Richard Crookes Constructions
Remedial Action Plan - Addendum 1
Sydney Modern Development
Art Gallery Road, Sydney NSW

Remedial Action Plan - Addendum 1

SYDGE234348-EH

| title: | COVER LAYER - WESTERN WEDGE AREA | | |

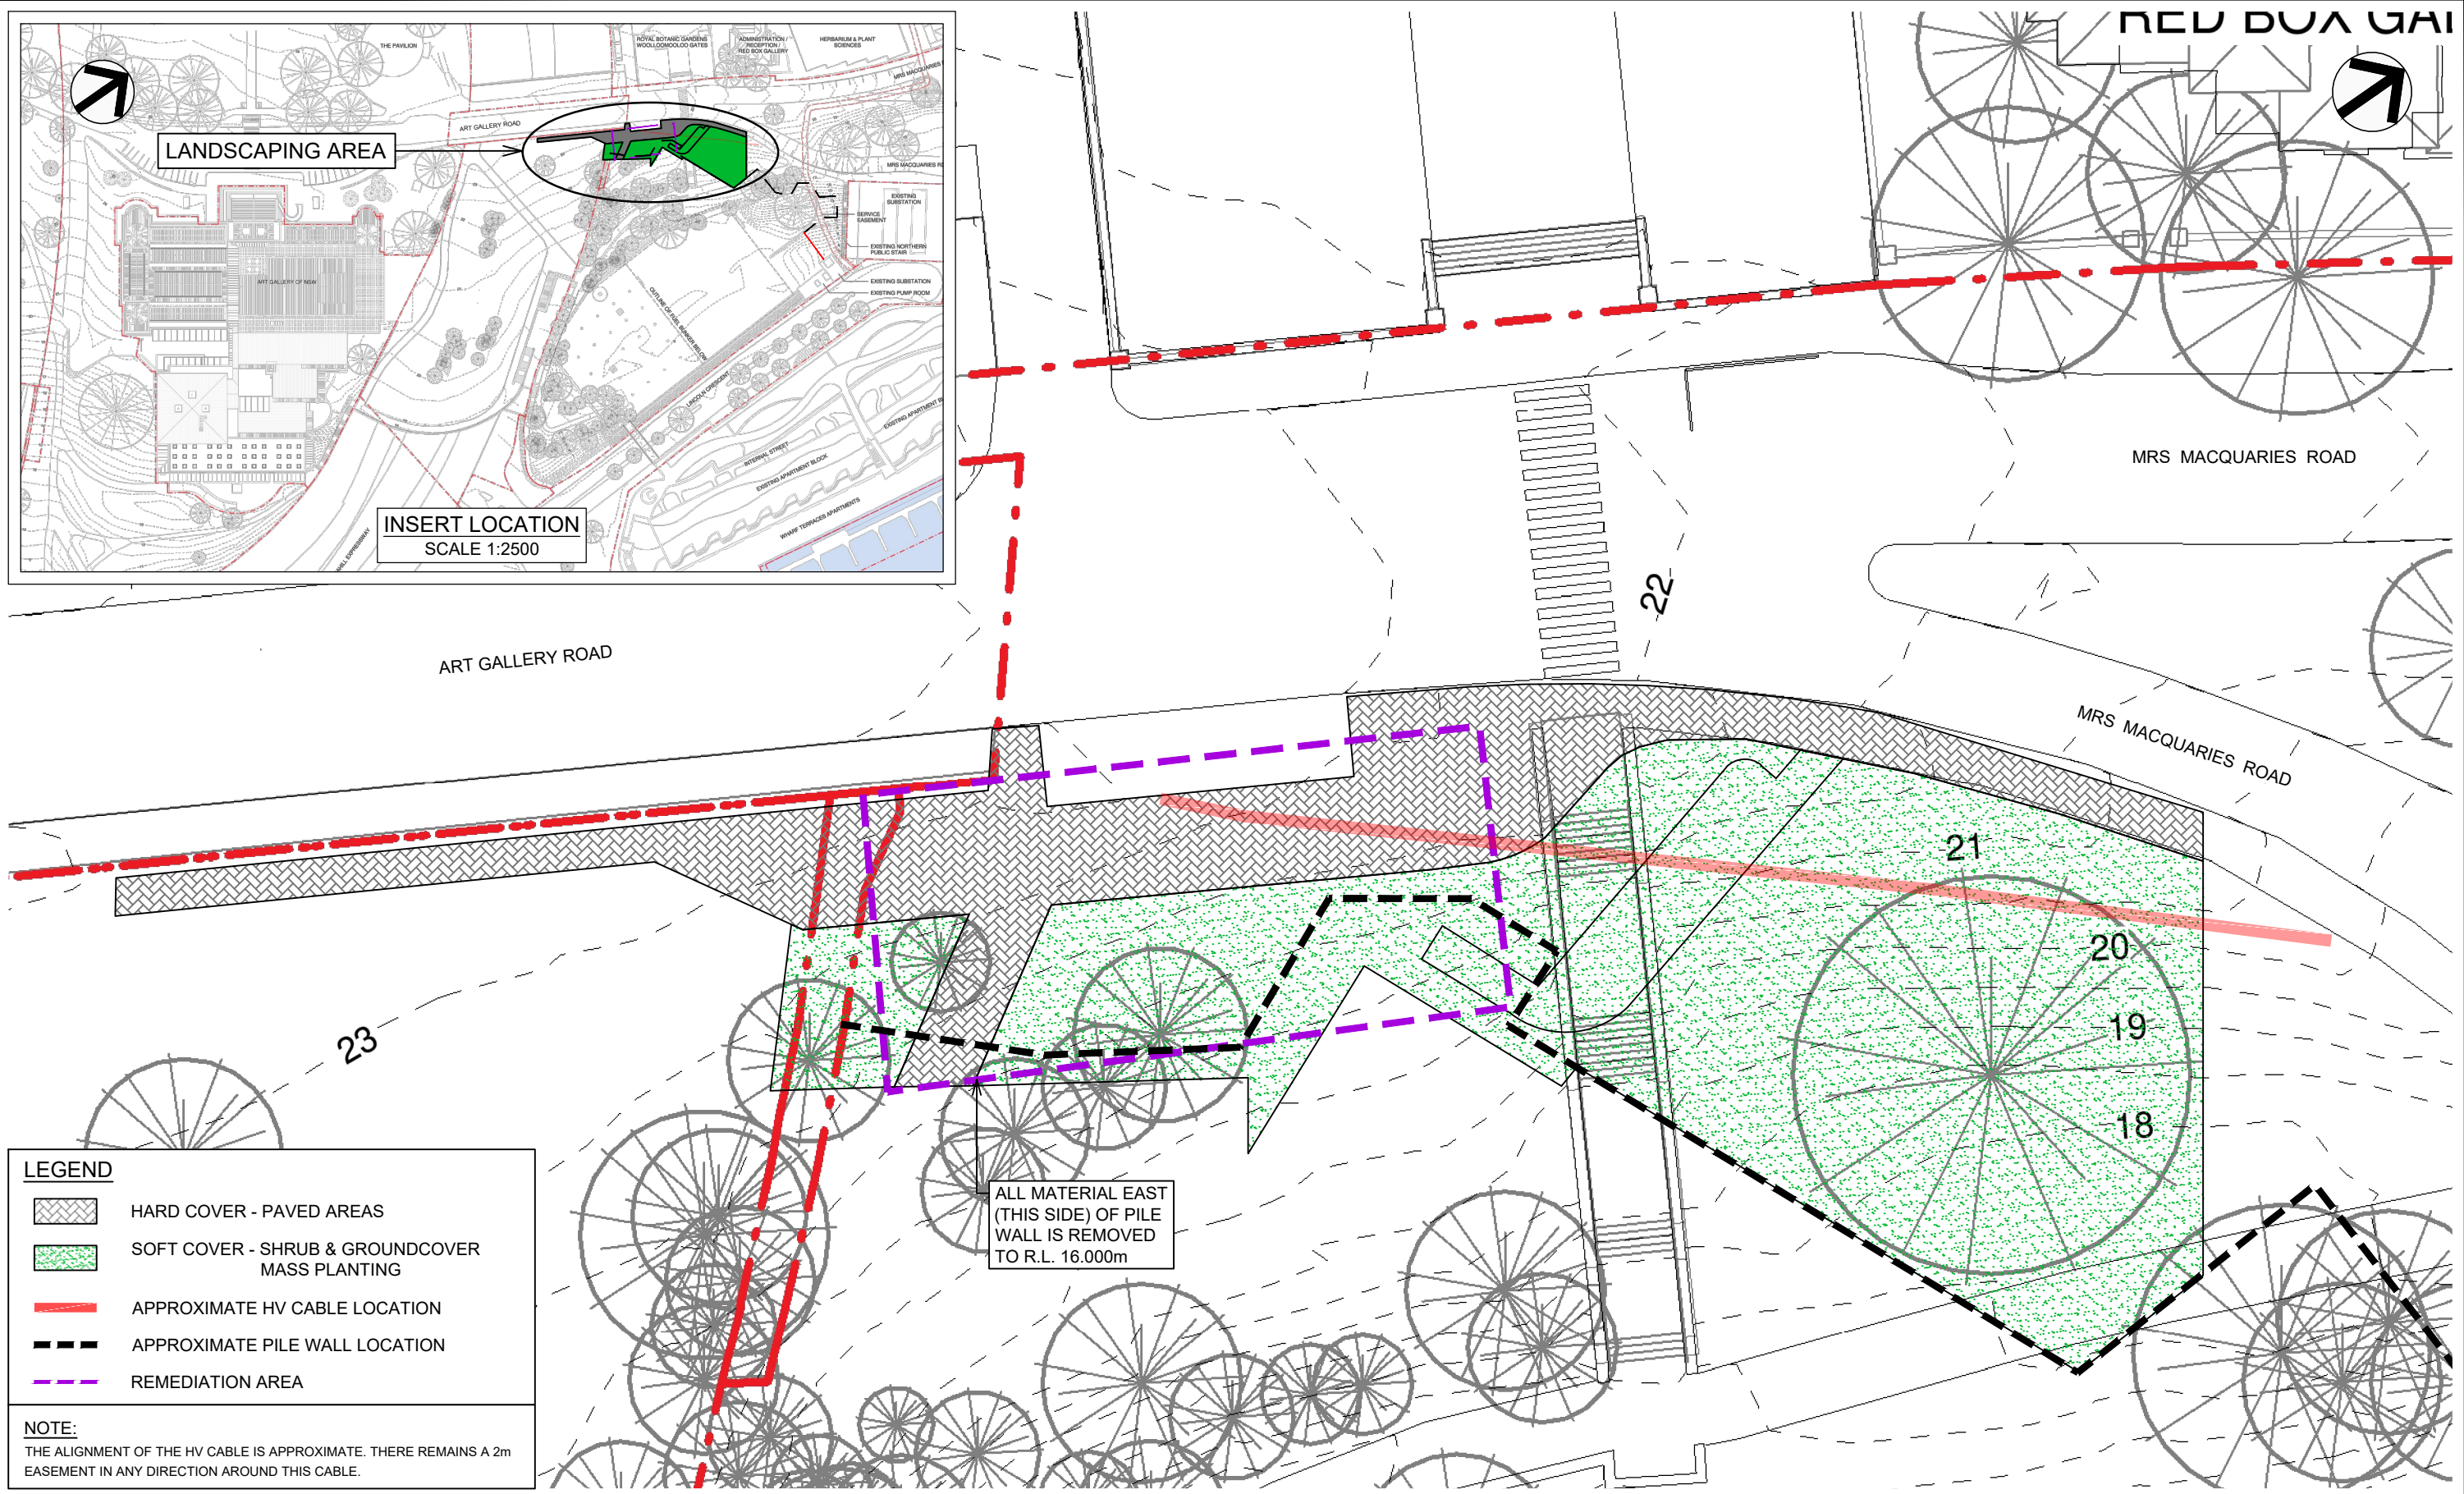
- An existing Ausgrid HV electrical cable is buried parallel to Art Gallery Road in the western half of the remediation area at a depth of approximately 0.8m below the current surface. Relocation of the HV cable is not feasible.

- Data from recent investigations indicate that soils impacted with PAH extend in a northern direction beyond the boundary of the Remediation Area defined within the RAP. Samples collected from SW01 at 0.9mbgs and SW05 at 0.2mbgs (refer Figure 1) reported concentrations of carcinogenic PAH (BaP TEQ) above the corresponding health investigation level (HIL) for recreational land uses. Conversely, samples collected from SW04 reported concentrations of BaP TEQ below the recreational HIL. The presence of the HV electrical cable and a mature tree restricts investigation in this area.

- Approximately 20% of the remediation area is on the eastern side of the pile retaining wall and requires removal.
- The discovery of asbestos impacted fill (Bonded ACM) within the North of Tank area on the western side of the retaining wall. This asbestos impact extends into a tree protection zone along the western edge of the North of Tank area which means that unless protected trees can be removed, the asbestos impacted fill beneath those trees remains.

| Site Area | Preferred Remedial Strategy |
|---|---|
| Remediation Area: Fill material around BH2 and BH4 (Western Wedge) | <ul style="list-style-type: none"> • Excavate and remove impacted fill materials within the Remediation Area east of the contiguous pile wall and dispose offsite as waste. • Fill material within the Remediation Area that is west of the contiguous pile wall will be retained within the site beneath an appropriate Cover Layer that will be managed over the long term. Some excavation and off-site disposal of soil from this area may be required to achieve design levels to establish landscaping and pavements. • The extent of the Cover Layer for the Remediation Area is shown on Figure 2. |

The Remediation Area shall form part of a landscaped strip between the Sydney Modern building and Art Gallery Road. Following regrading works (mostly addition of fill) required to achieve the design level, historical fill within the Remediation Area shall be covered with materials to mitigate health risks future site users. The presence and shallow depth of the HV cable restricts the thickness of the Cover Layer that can be placed in the Remediation Area. As such, it is proposed that this Cover Layer utilise landscaping and pavements proposed within these areas to separate impacted fill from future site users.

Based on the concept landscape design plans, the Remediation Area will be covered by a combination of hard pavement and soft landscaped materials and shown in Figure 2. This area is designed for movement of pedestrians and not as a location where users would occupy for long periods (a few hours). The Cover Layers shall be formed as follows:

- **For new soft landscaping areas:** a high tensile strength biaxial geogrid with nominal aperture size of 30-40mm¹ shall be anchored over historical fill material, and covered by a minimum 200mm thick clean validated imported soil as planting media and mulch layer. Landscape design plans require 'shrub and groundcover mass planting' which will restrict site visitors accessing the soil, and limit the potential for eroding the planting media, once the plants are established.

- **For existing mature trees retained in the development:** placement of a high tensile strength biaxial geogrid with nominal aperture size of 30-40mm over the root zone that requires protection, and place a nominal 100mm thick layer of mulch. The edge of the root zone shall be surrounded by a proprietary hard edging material specified by the Landscape Architect that aims to contain the mulch cover over the root zone and separates these areas from other cover materials.

- **For hard pavement areas:** a high tensile strength biaxial geogrid with nominal aperture size of 30-40mm shall be placed over historical fill material, covered by a 100mm thick layer of clean validated imported pavement subbase material.

| title: | COVER LAYER - NORTH TANK AREA |

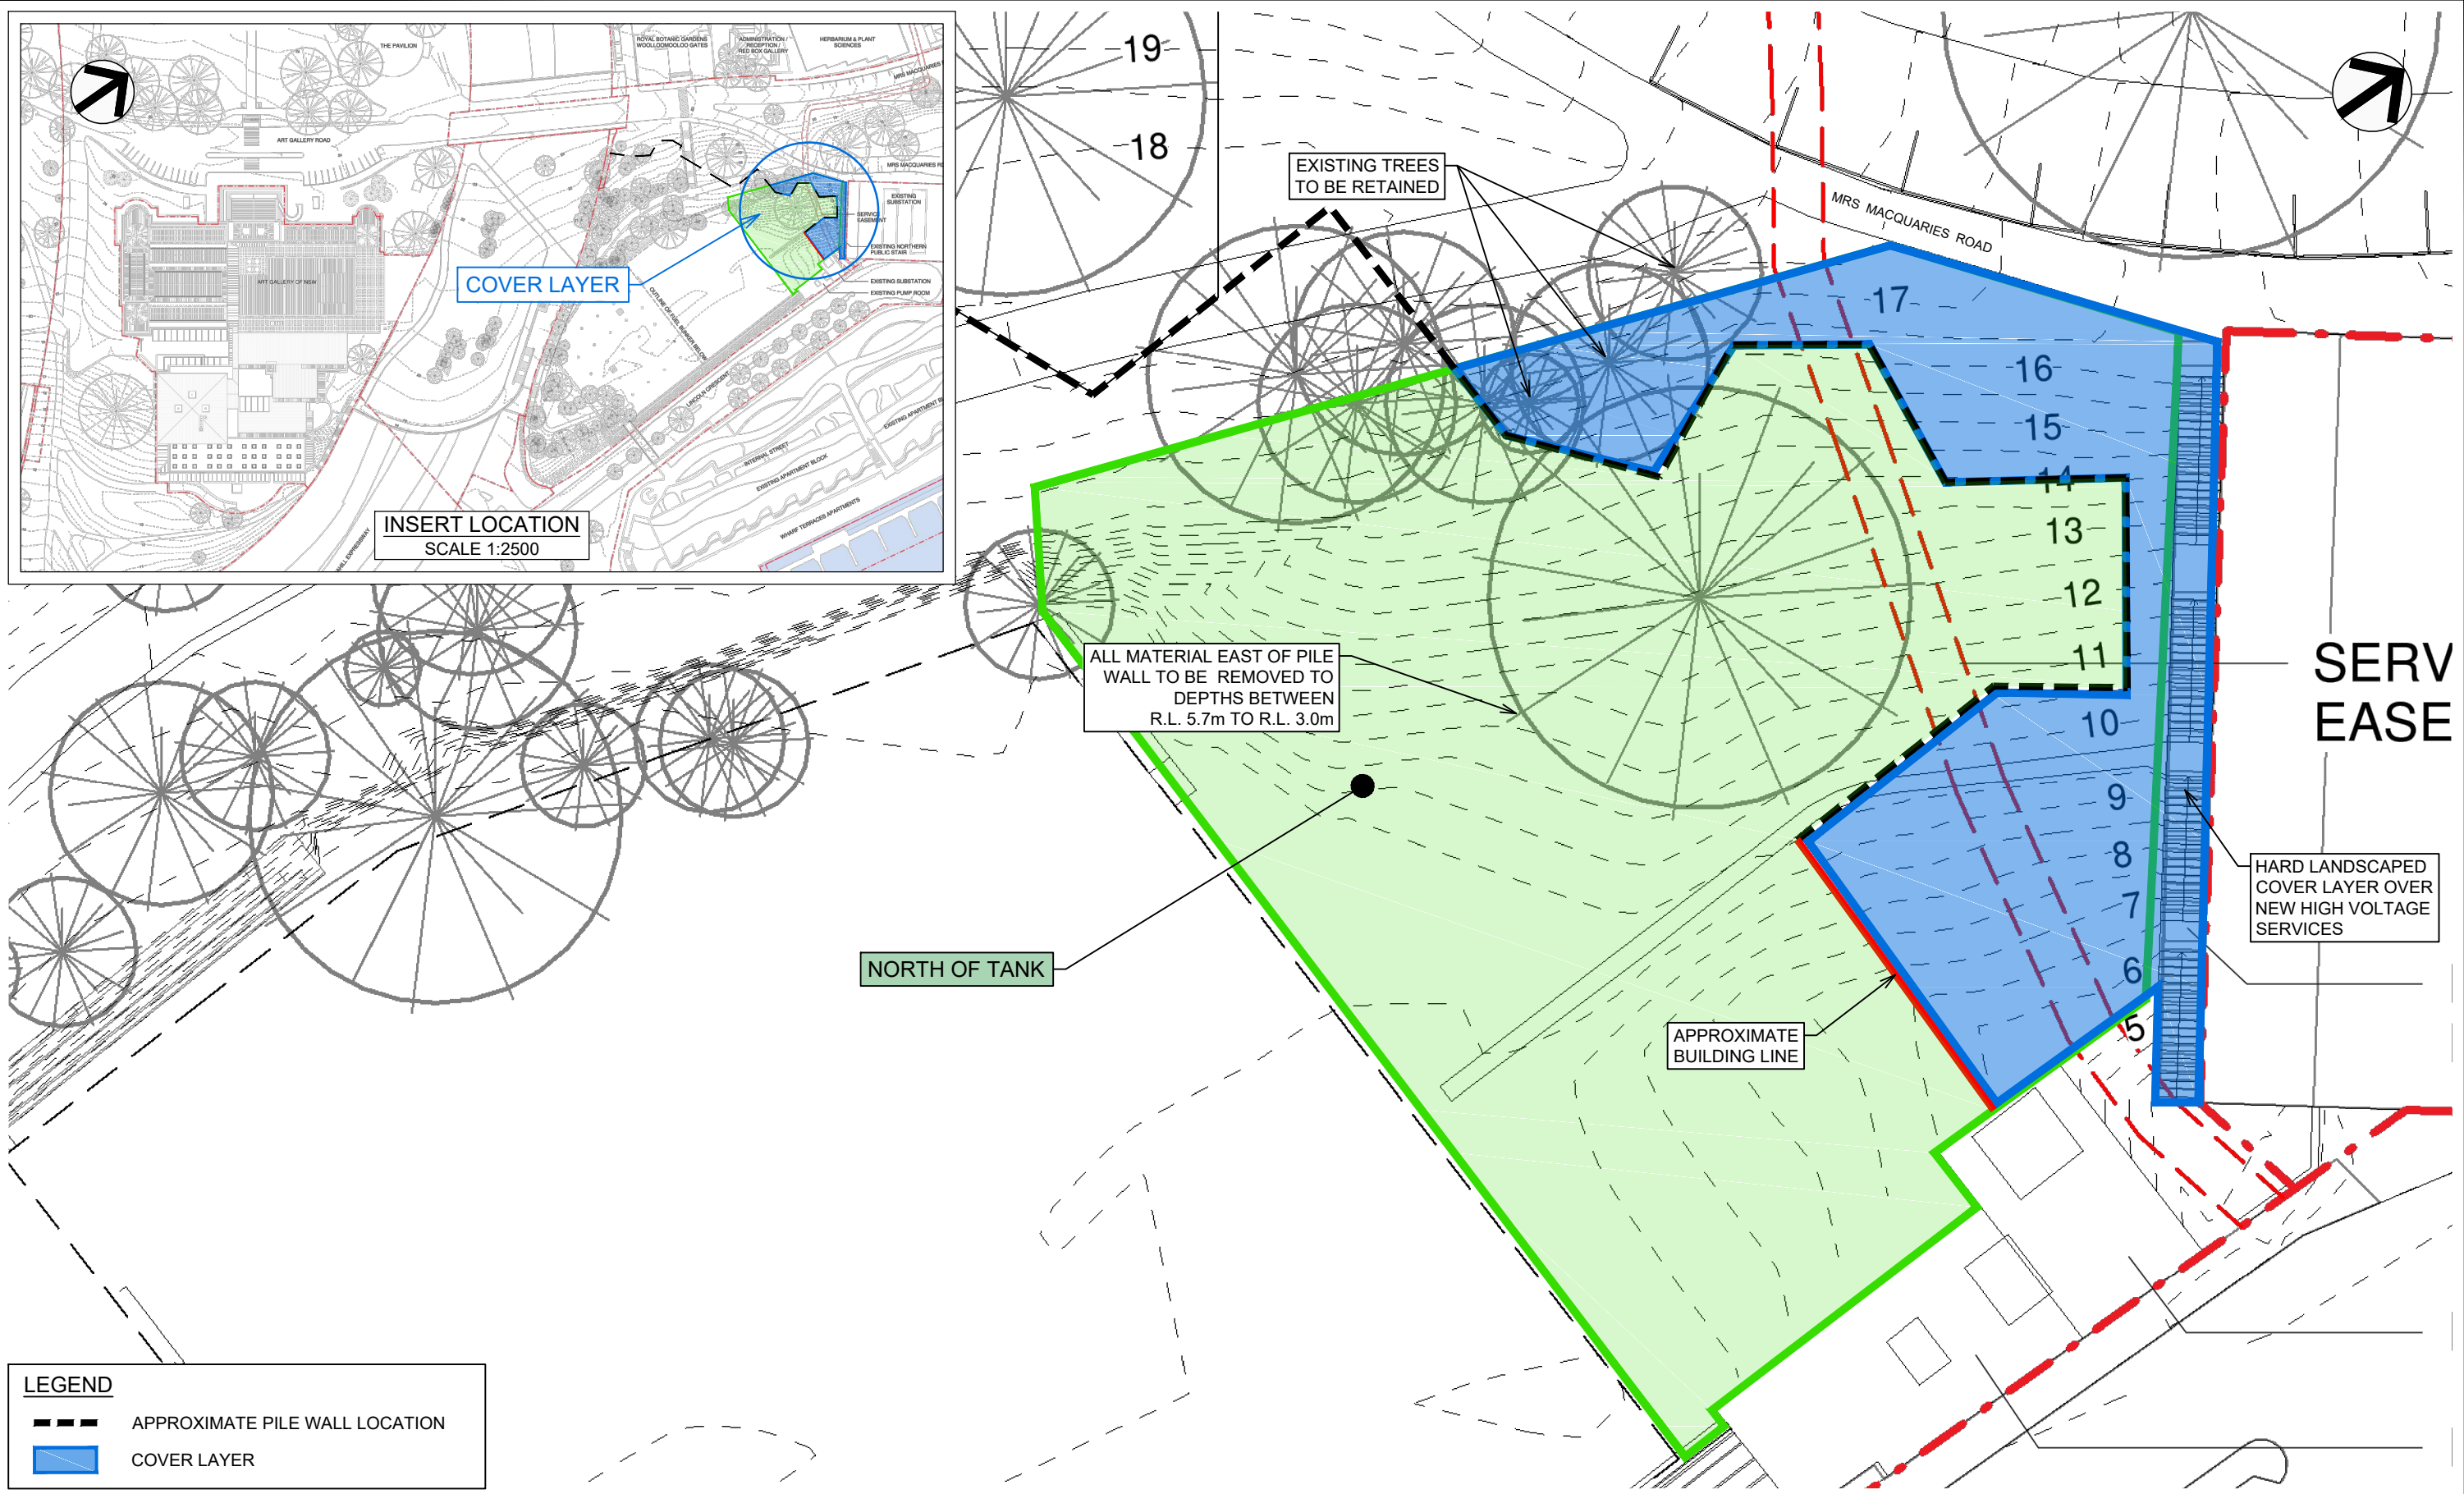
The proposed development includes a contiguous pile retaining wall in the North of Tank and Western Wedge areas as shown as a black dashed line in Figure 1. Existing topsoil and fill material from the eastern side of that wall will be removed entirely to provide a void with a floor level of approximately 9mAHD to allow future construction. Consequently, the majority of the soil from within the two areas where further investigation was required will now be removed entirely. As such, further investigations outlined within the RAP has no purpose and therefore will no longer be completed.

It is assessed that the potential impact of hydrocarbon odours at 1 m depth in fill on the western side of the pile wall is negligible because this area will remain open to the air and potential for odour intrusion into the gallery space is negligible due to the presence of the pile wall. Exposure risks via direct contact pathways will be managed through the placement of a Cover Layer, as described within Table 3.1.

| Site Area | Preferred Remedial Strategy |
|---|---|
| North of Tank | <ul style="list-style-type: none"> • Excavate and remove asbestos impacted fill materials east of the contiguous pile wall and dispose offsite as waste. • Fill material west of the contiguous pile wall will be retained within the site beneath an appropriate Cover Layer that will be managed over the long term. Some |

| Site Area | Preferred Remedial Strategy |
|-----------|---|
| | <p>excavation and off-site disposal of soil from this area may be required to achieve design levels.</p> <ul style="list-style-type: none"> The extent of the Cover Layer for the North of Tank Area is shown on Figure 3. |

Based on the landscape design information provided by RCC, this area will be covered by a combination of hard pavement and soft landscaped materials. The extent of the Cover Layer proposed in the North of Tank area is shown on Figure 3.

- **For soft landscaping areas:** a high tensile strength biaxial geogrid with nominal aperture size of 30-40mm shall be anchored over historical fill material and covered by a minimum 200mm thick clean validated imported soil as planting media. The steep topography of this area will limit site visitors accessing the soil beneath planting. The geogrid will enable plants to stabilise the soil and minimise erosion.

- **For existing mature trees retained in the development:** placement of a high visibility geotextile marker layer (i.e. Bidim® A34 or equivalent specification) over the root zone that requires protection, and place a nominal 100mm thick layer of mulch. The edge of the root zone shall be surrounded by a proprietary hard edging material specified by the Landscape Architect that aims to contain the mulch cover over the root zone and separates these areas from other cover materials. The trees remaining within the North of Tank Area are identified on Figure 3.

- **For hard pavement areas:** A high visibility geotextile marker layer (i.e. Bidim® A34 or equivalent specification) shall be placed over historical fill material, covered by a 100mm thick layer of clean validated imported pavement subbase material.
